City of Binghamton
Water Street Development Corporation
Special Meeting
Wednesday April 12, 1:00 PM
Mayor's Conference Room, City Hall, 4th floor

RESOLUTION 23-6 A RESOLUTION OF THE CITY OF BINGHAMTON WATER STREET DEVELOPMENT CORPORATION TO ACCEPT A GARAUNTEED MAXIMUM PRICE OF \$22,060,245 FOR THE DEVELOPMENT OF THE PARKING GARAGE AND \$3,050,300 FOR THE SIXTH FLOOR PODIUM BY UNITED - PIKE DEVELOPMENT JV, LLC

City of Binghamton: Water Street Garage

Water St Municipal Parking Garage Contract Document List
4/5/2023

S-106a

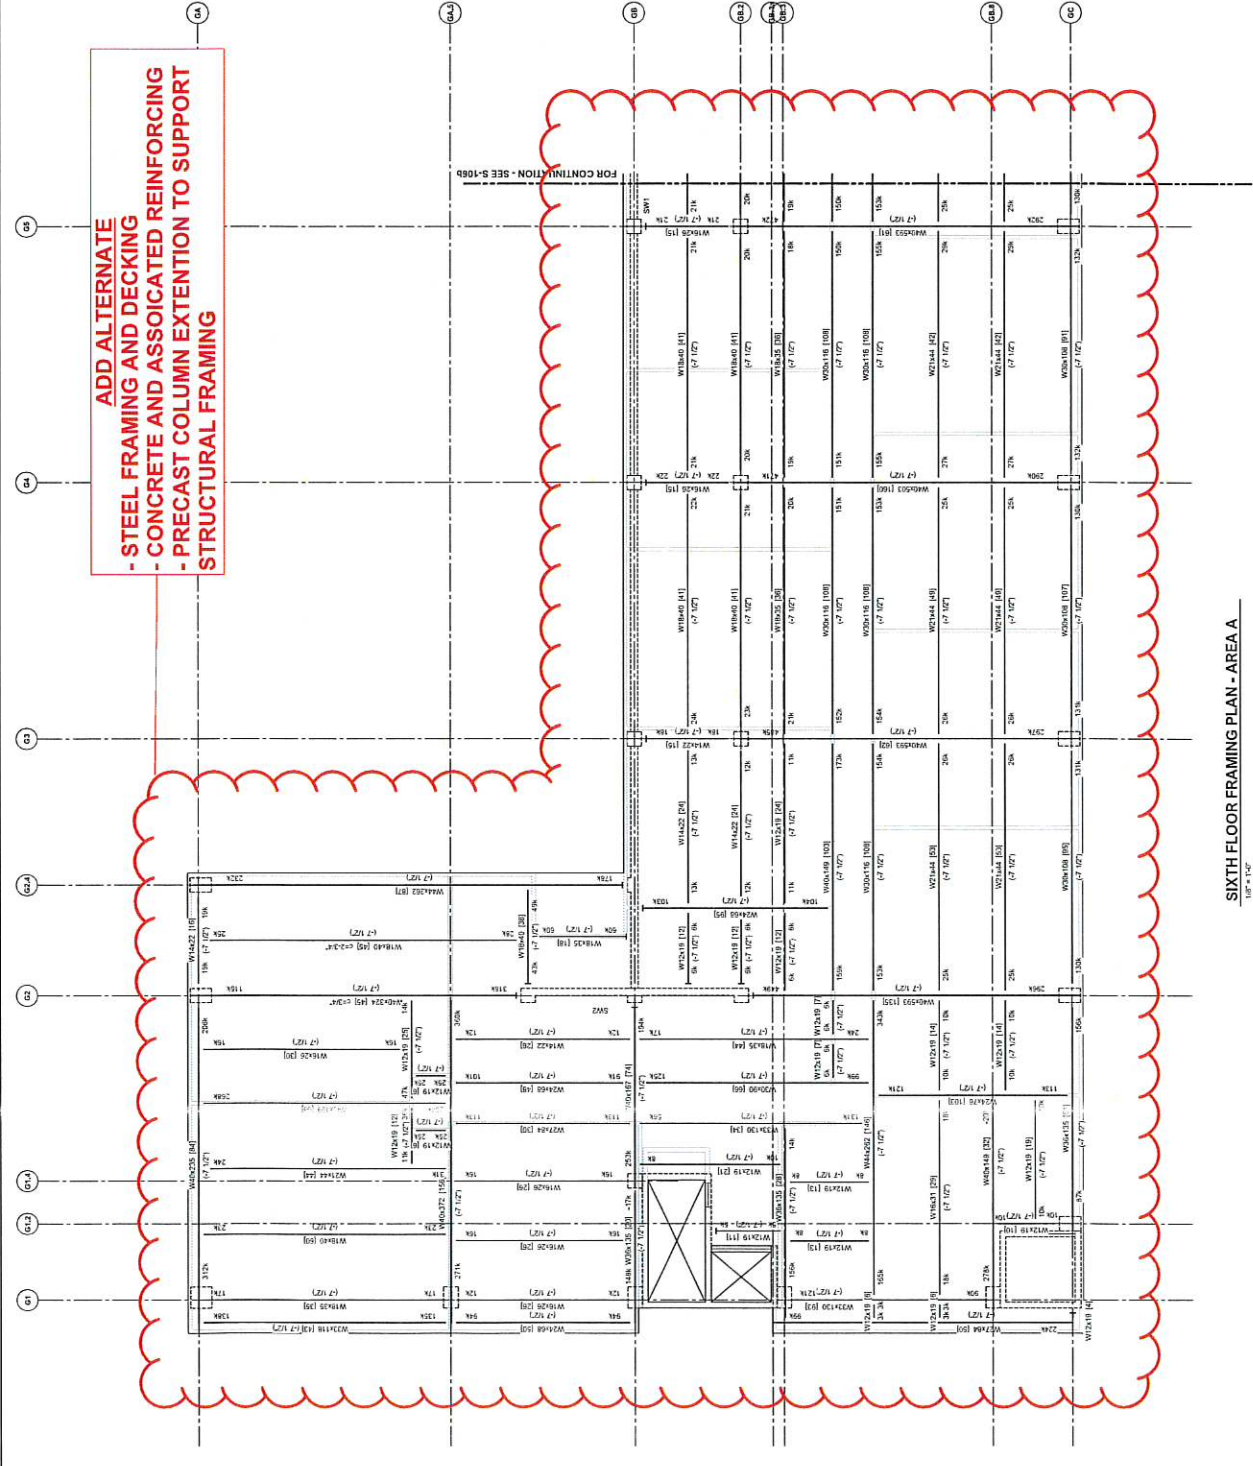
- **Add Alternate - 6th Floor Podium**
 - *Alternate Description:*
 - *Extension of precast columns to support structural framing as shown on S-106a and S-106b*

- *Addition of structural steel framing and decking and associated embeds as shown on S-106a and S-106b*
 - *Placement of the concrete slab on deck and associated reinforcing as shown on S-106a and S-106b*

**ADD ALTERNATE
- STEEL FRAMING AND DECKING
- CONCRETE AND ASSOCIATED REINFORCING
- PRECAST COLUMN EXTENSION TO SUPPORT
STRUCTURAL FRAMING**

STEEL DESIGN SHOWN FOR PRELIMINARY PRICING ONLY. FINAL DESIGN IS PENDING DESIGN AUTHORIZATION FOR RESIDENTIAL FLOORS ABOVE.

S-106b

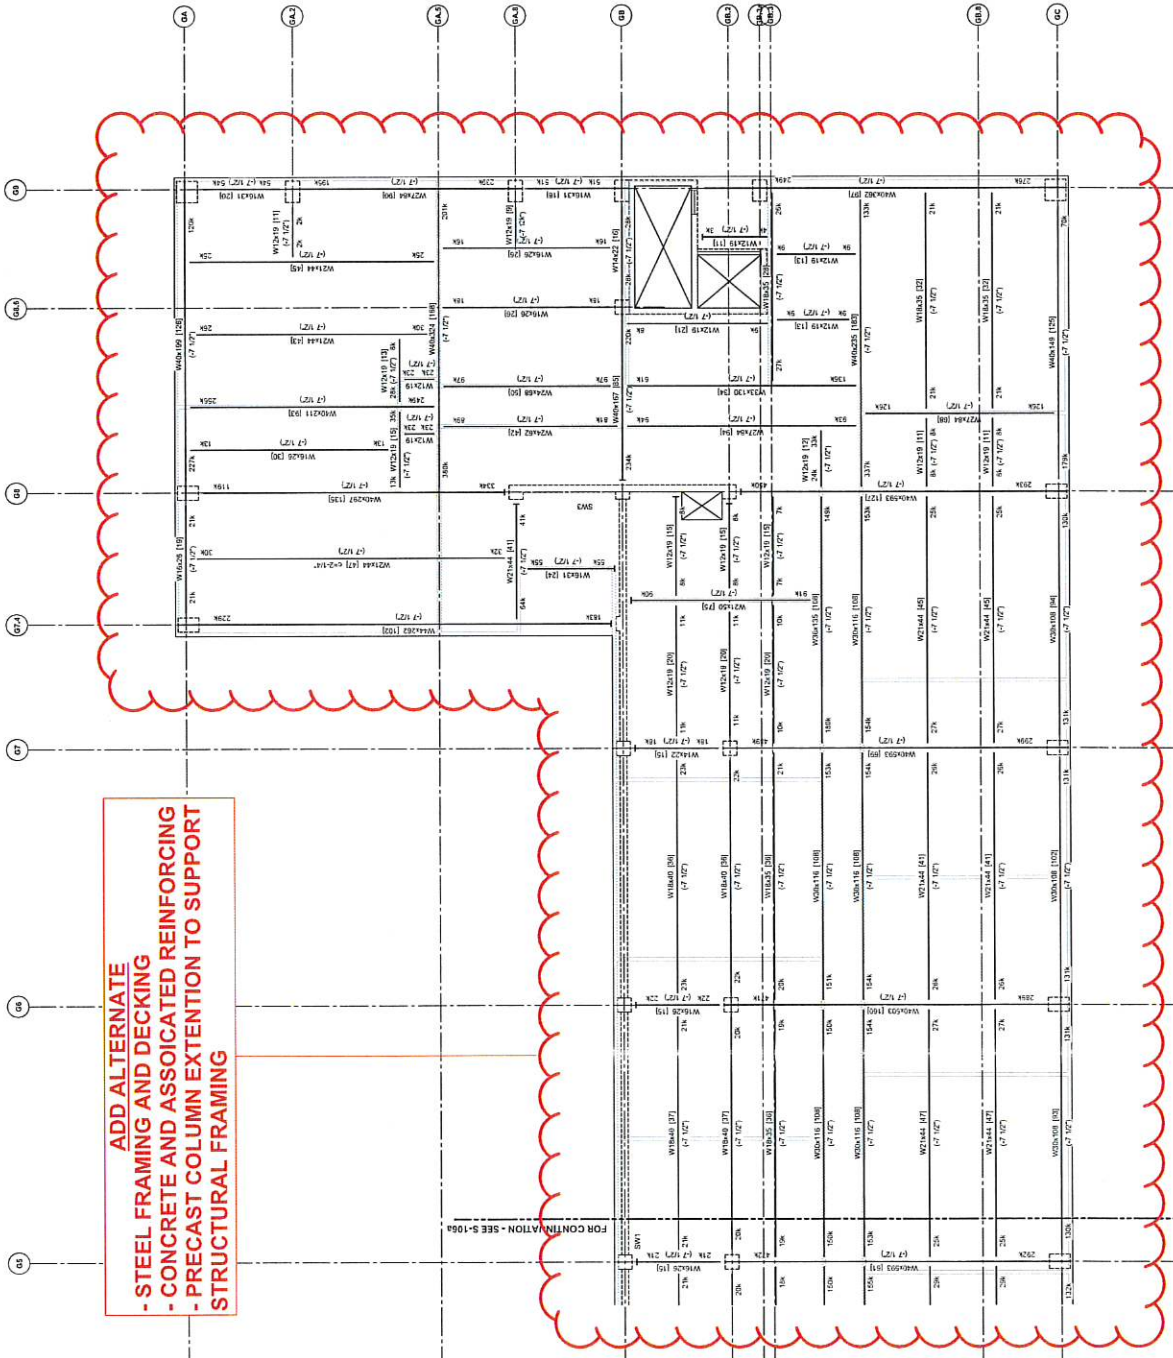
**ADD ALTERNATE
 - STEEL FRAMING AND DECKING
 - CONCRETE AND ASSOCIATED REINFORCING
 - PRECAST COLUMN EXTENSION TO SUPPORT
 STRUCTURAL FRAMING**

**STEEL DESIGN SHOWN FOR
 PRELIMINARY PRICING ONLY.
 FINAL DESIGN IS PENDING FOR
 DESIGN AUTHORIZATION FOR
 RESIDENTIAL FLOORS ABOVE.**

**DRAWING TITLE
PARKING GARAGE FIRST LEVEL PLAN -
LEVEL PLAN -
CONDUIT
ROUTING
E100**

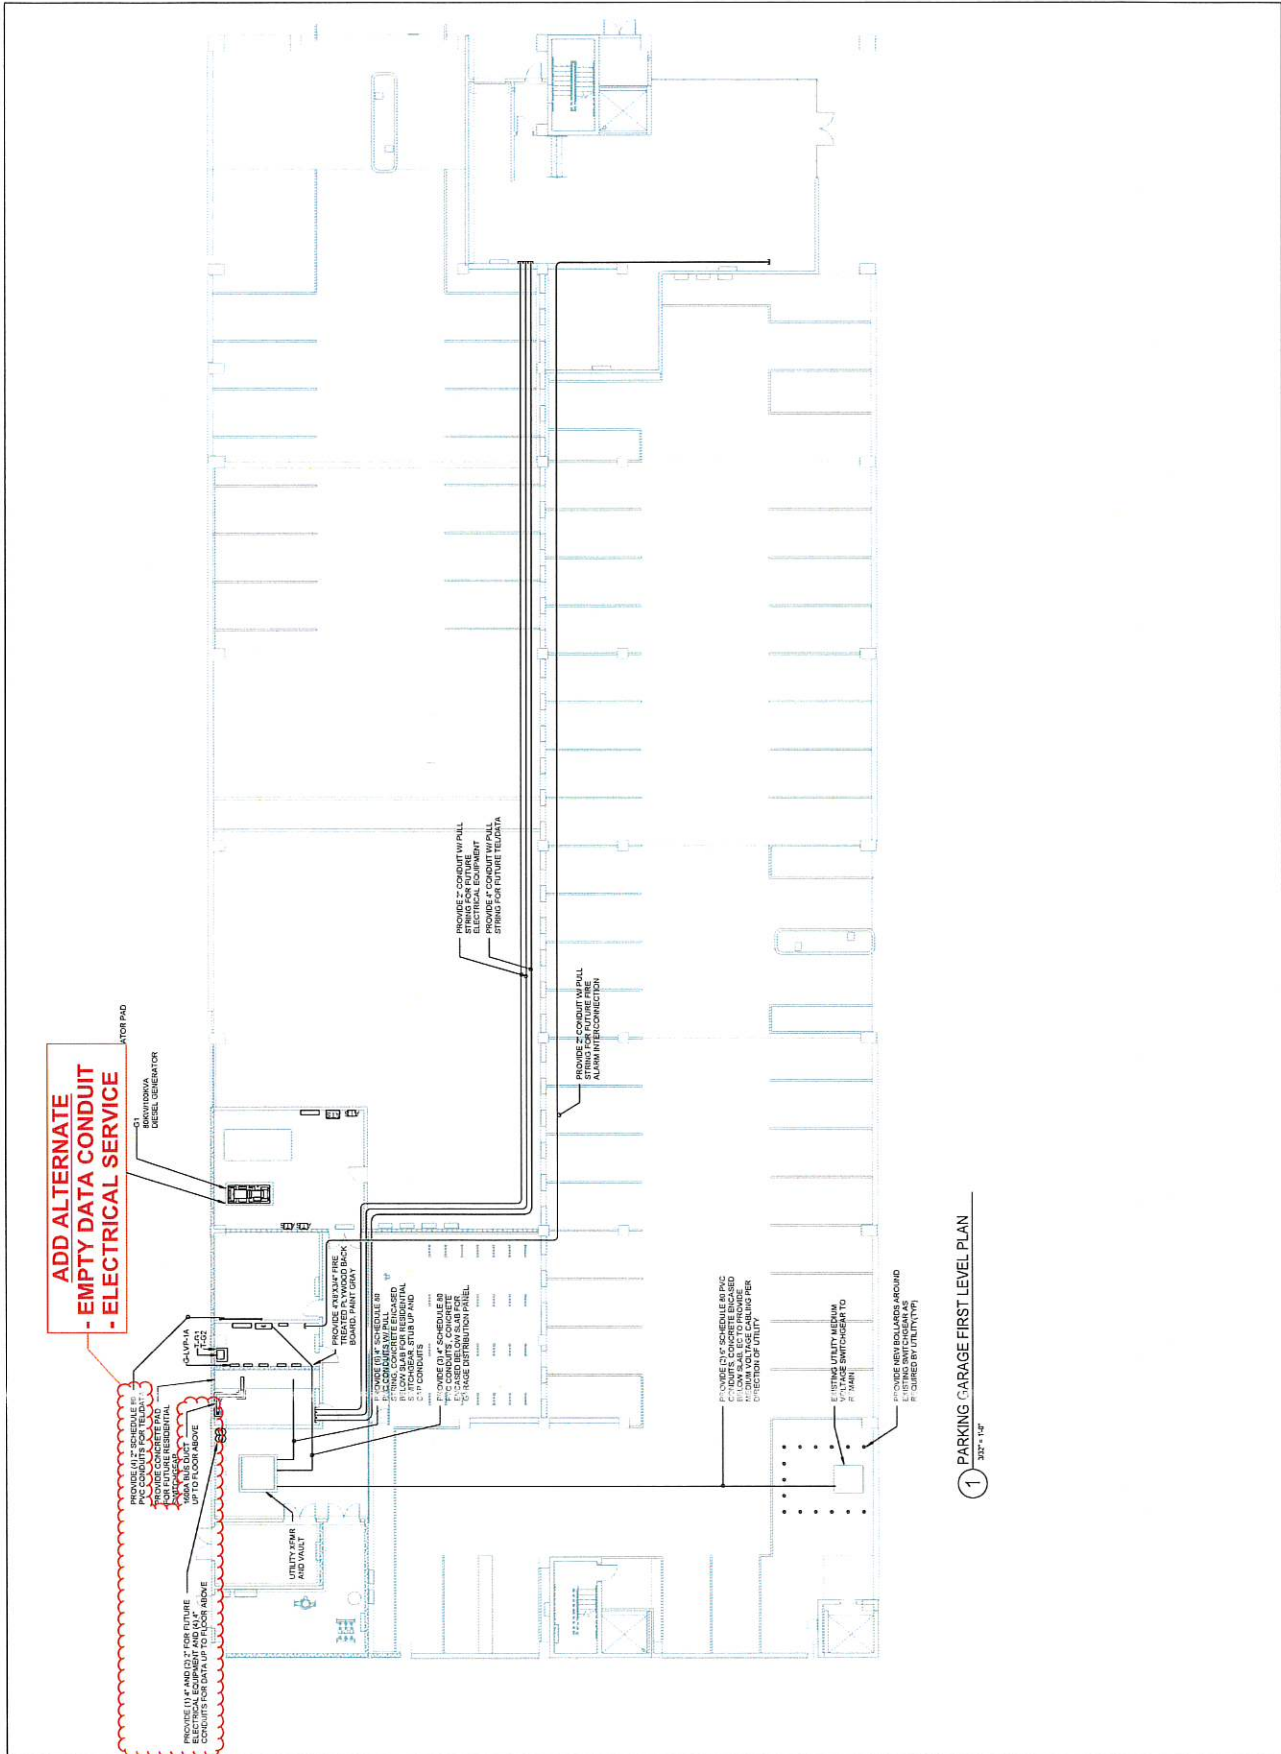
- *Installation of the electrical service conduit and cabling that would service the apartments as well as the empty data conduits from 1st floor to 6th floor as shown on E-100, E-112 through E-115*

E112

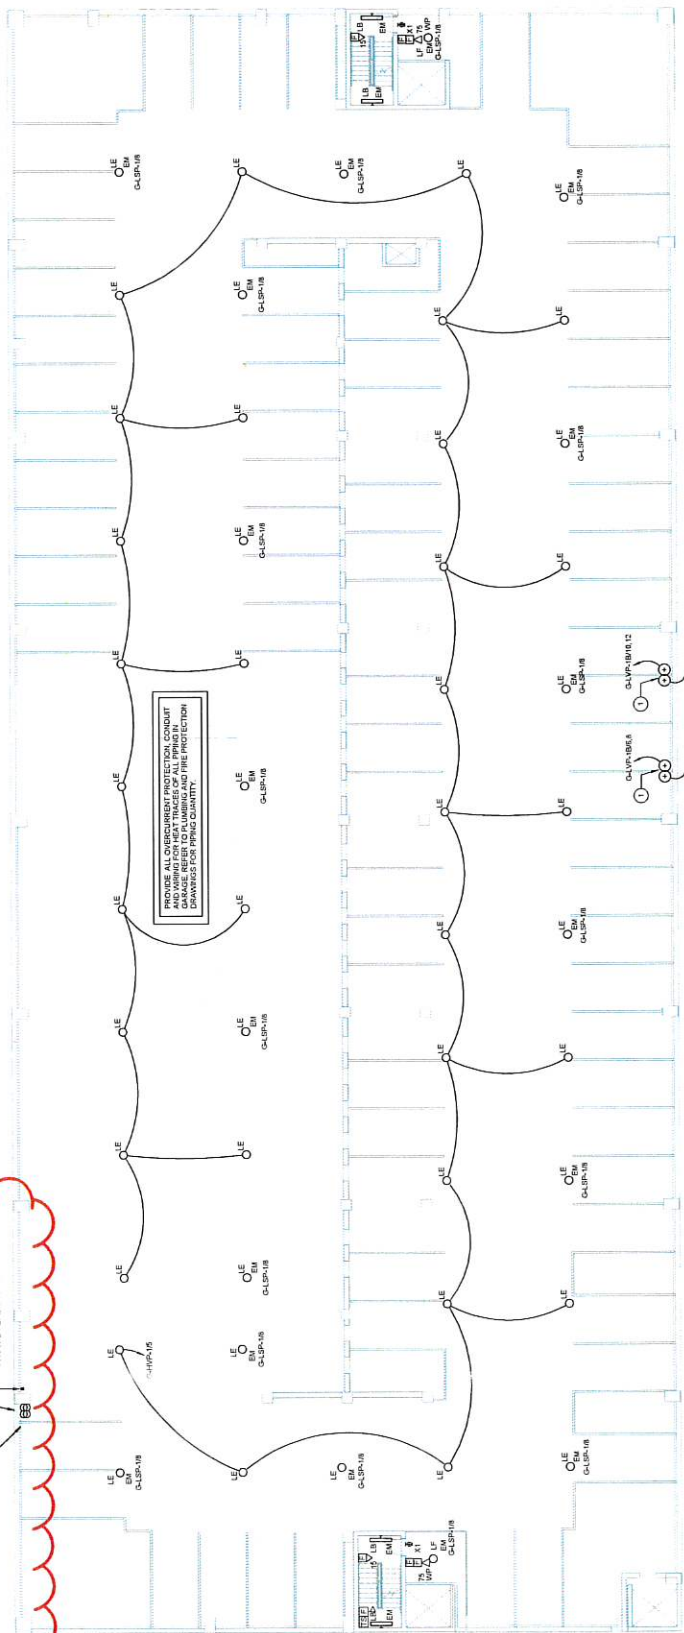
**ADD ALTERNATE
- EMPTY DATA CONDUIT
- ELECTRICAL SERVICE**

E114

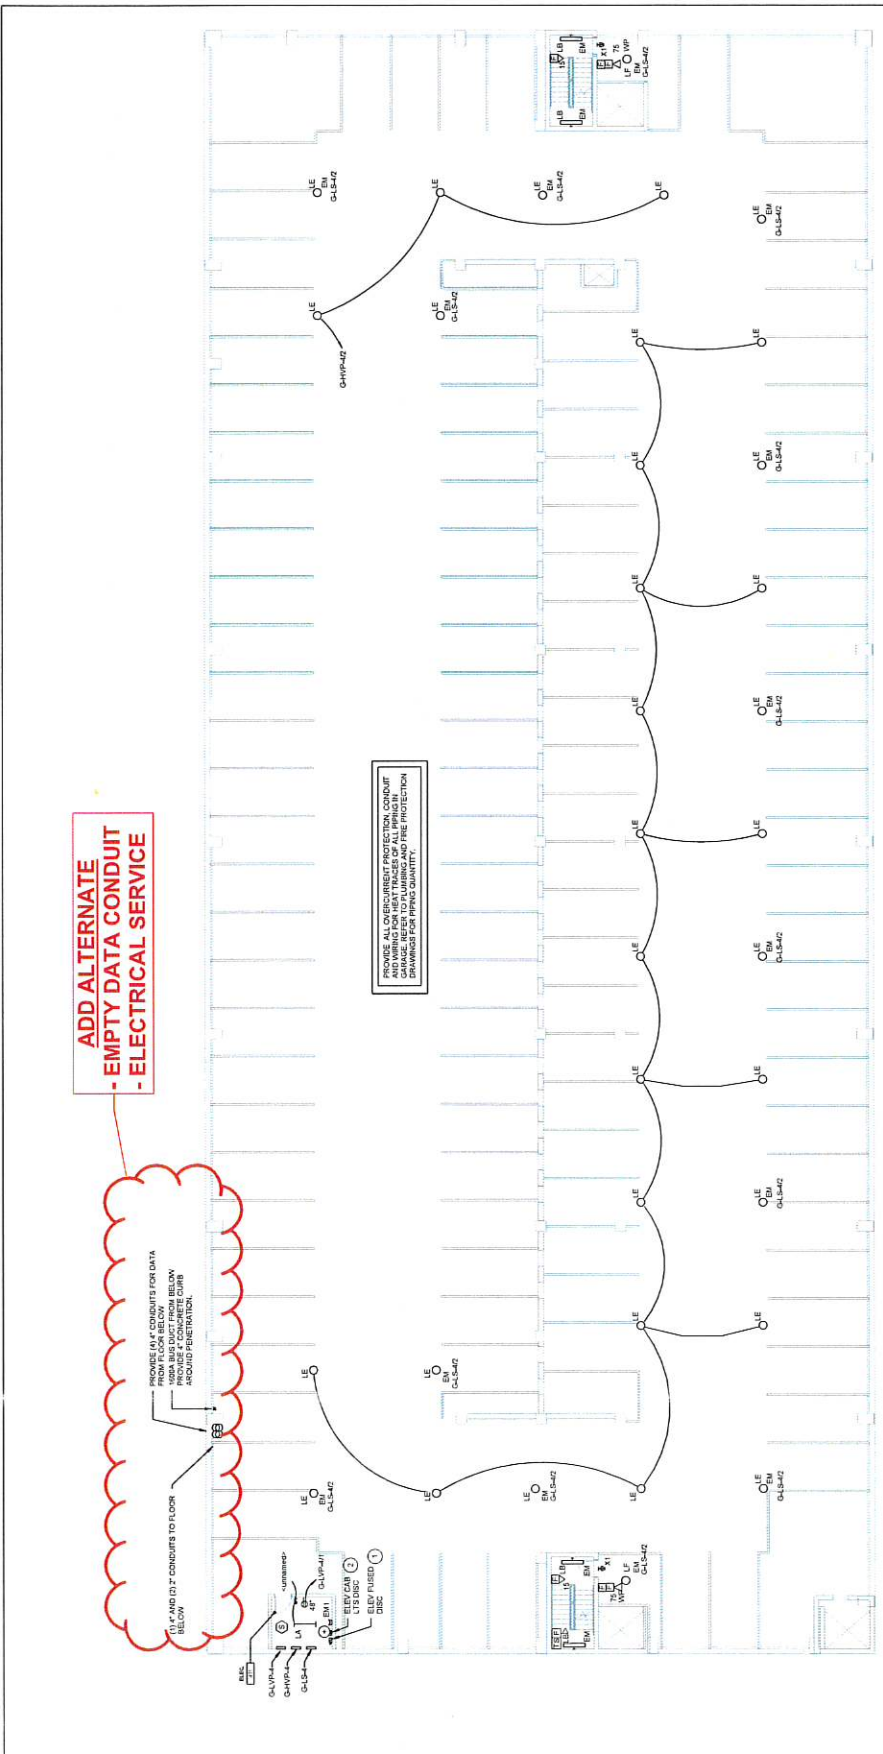
**ADD ALTERNATE
- EMPTY DATA CONDUIT
- ELECTRICAL SERVICE**

E115

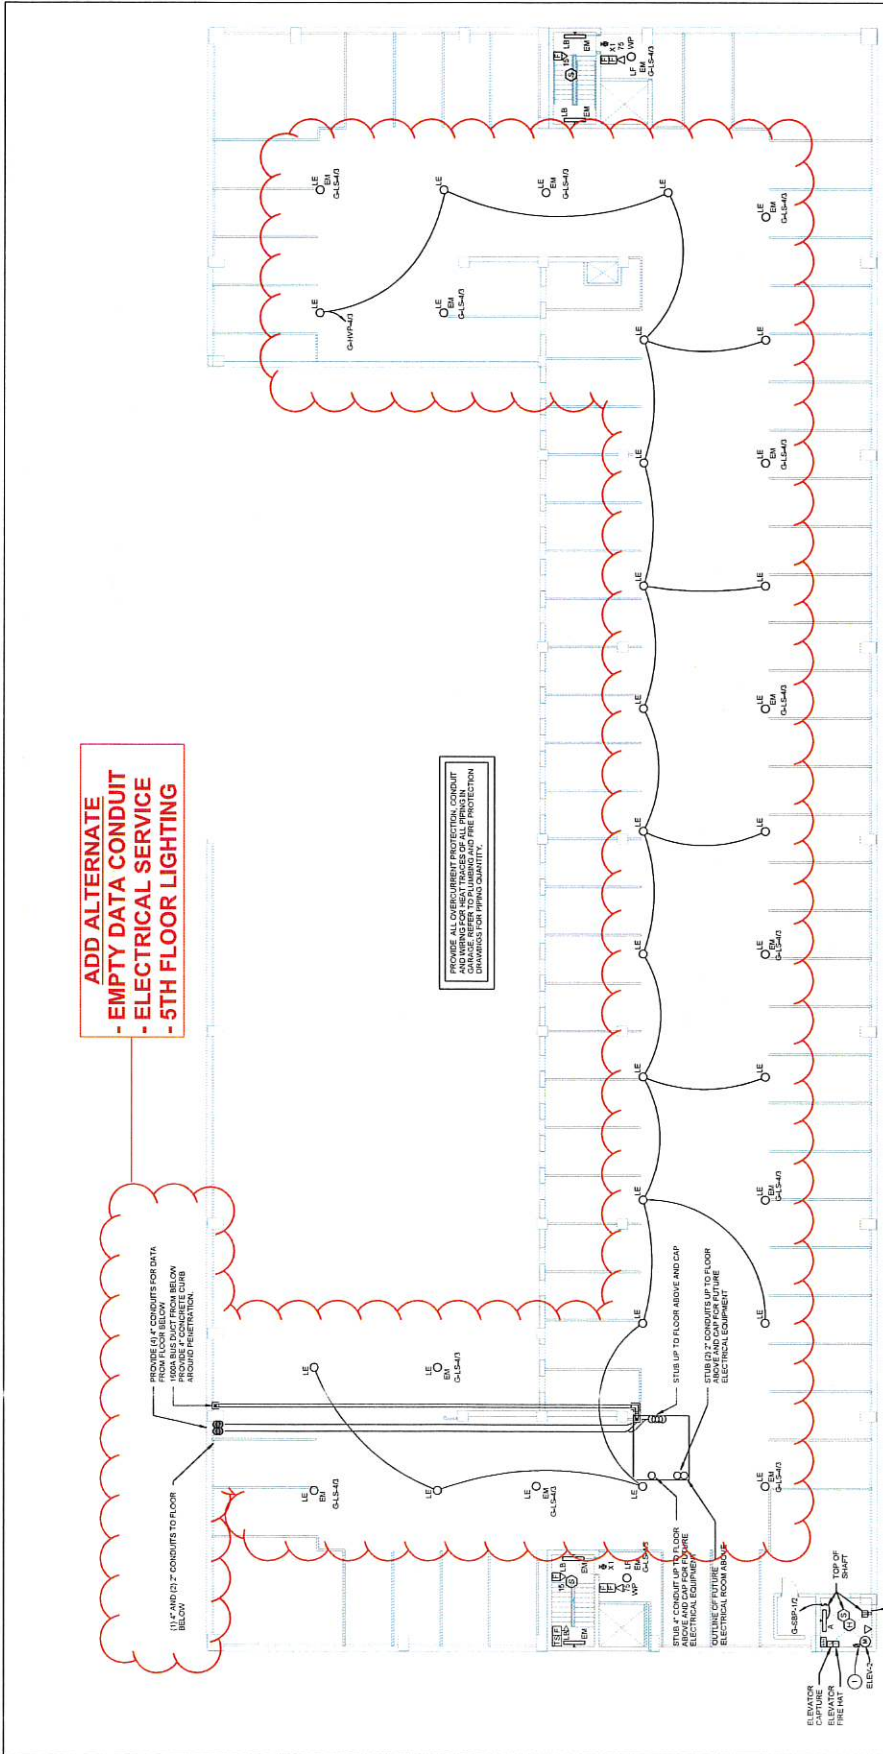
- *Installation of 5TH floor deck mounted lighting as shown on E-115. The intent would be to replace this lighting with pole mounted fixtures*
 - *Installation of the 5th floor fire protection system per as shown on FP115*

ADD ALTERNATE
- EMPTY DATA CONDUIT
- ELECTRICAL SERVICE
- 5TH FLOOR LIGHTING
